SUNDRY NOTICES AND REPORTS ON WELLS

SAN JUAN 32-7 UNIT 63

Hilcorp Energy Company requests permission to recompleate the subject well in the Blanco Mesaverde fotation and downhole commingle with the existing Dakota formation. Please see the attached procedure, wellbore diagram, gas capture plan and plat. A closed loop system will be used. Interim reclamation will be performed after surface disturbing activities.

CONDITIONS OF APPROVAL

SAN JUAN 32-7 UNIT 63 - CURRENT WELLBORE SCHEMATIC

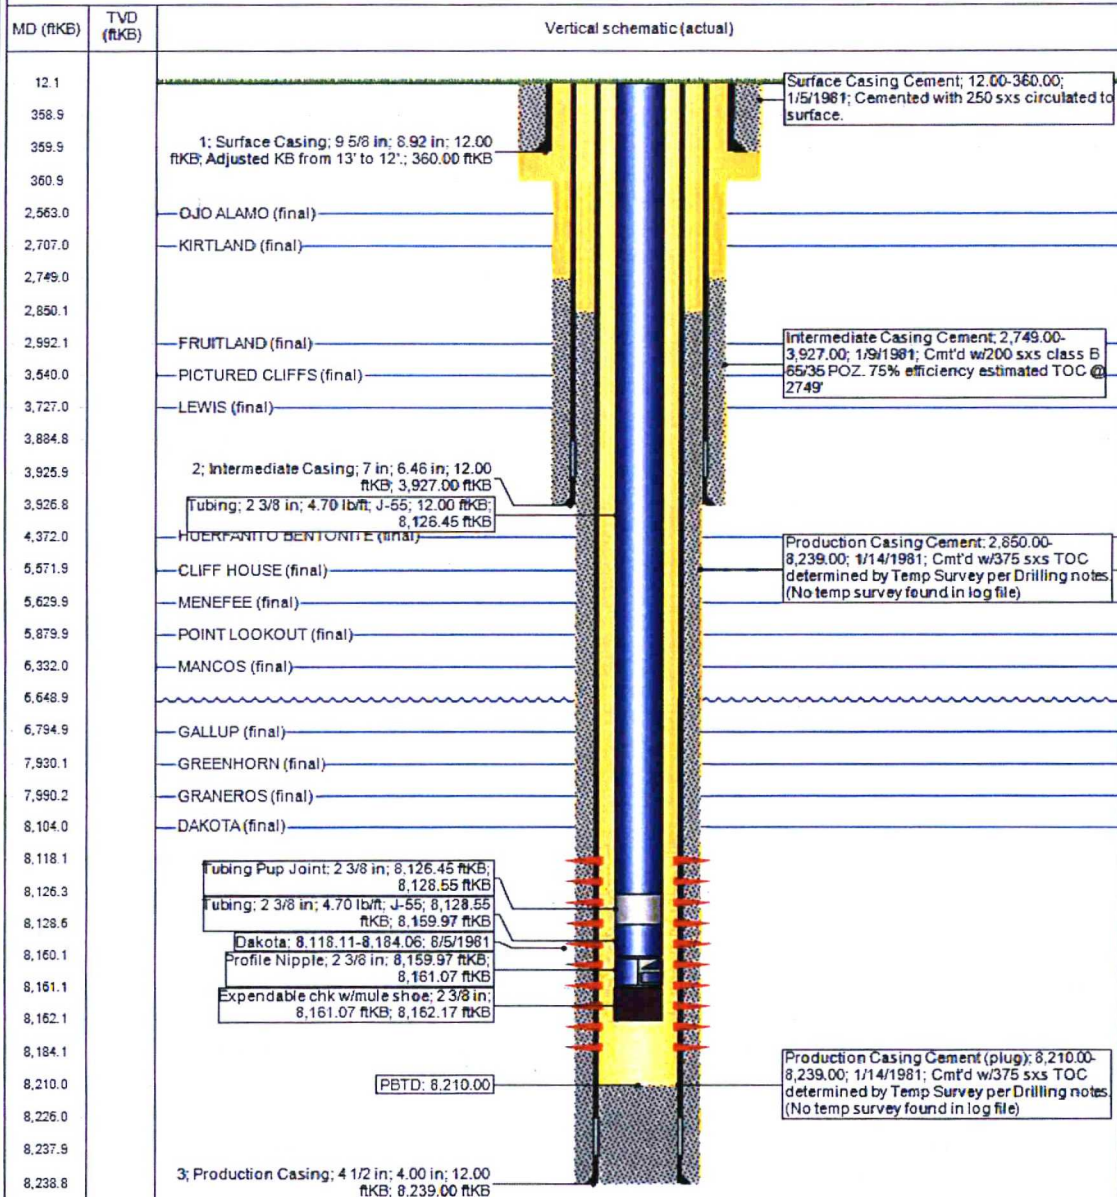
2. The following modifications to your recompletion program are to be made:

- a) Upon rigging up, record Bradenhead pressure and monitor same during recompletion operations. Notify BLM and NMOCD if anomalous pressure changes occur. Provide monitoring results in the subsequent Report of Operations.
- b) Casing pressure test for fracture stimulation operations cannot exceed the internal yield strength of the casing including a 20% safety factor unless a waiver is granted. Stimulation operations cannot exceed this test pressure.
- c) CIBP for base of fracture stimulation to be set less 50' above top existing perforation.
